DEPARTMENT OF PLANNING AND ZONING

DATE: February 21, 2020

TO: Potomac Yard Design Advisory Committee (PYDAC)

SUBJECT: North Potomac Yard, Phase 1 Development – Group 1 Buildings

Attachment 1: Diagram of Building Groups 1 and Group 2 in North Potomac Yard Phase 1 Development

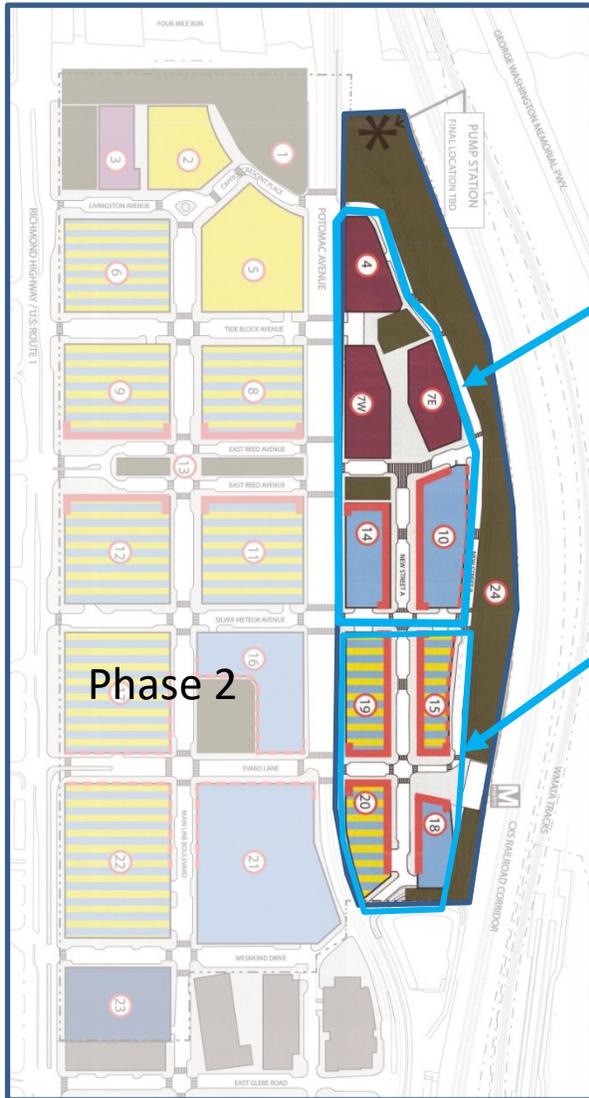
Each stage of the review will break the eight buildings into two groups; Group 1 and Group 2 (See Attachment 1 for a diagram of Group 1 and Group 2). The smaller grouping of buildings will permit PYDAC to have a focused review and discussion of four buildings at a time.
